## Prince Cove Marina

## Town of Barnstable ADA Transition Plan

Institute for Human Centered Design

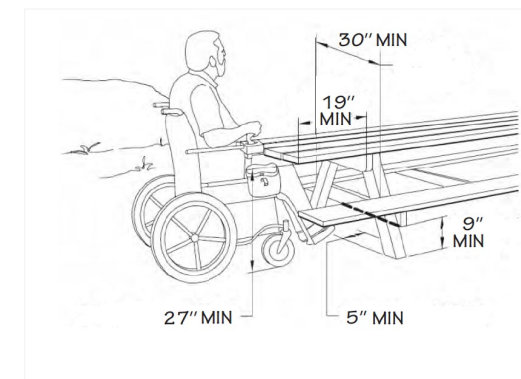
Accessibility issues include excessive change in level and running slope at the gangway greater than the maximum allowed and the width of the boarding pier is less than the minimum

allowed. In addition, the boarding pier lacks the required edge protection

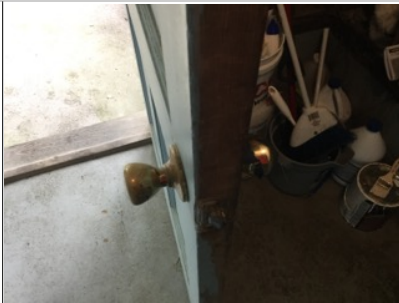
5	Route by Deck to Boat Ramp	Ext.		Exterior Access Route	Exterior		Cross slope > 1:50 (2.00%)	6.6%	Reduce cross slope to be no steeper than 1:50 (2.00%).	1	-	\$0
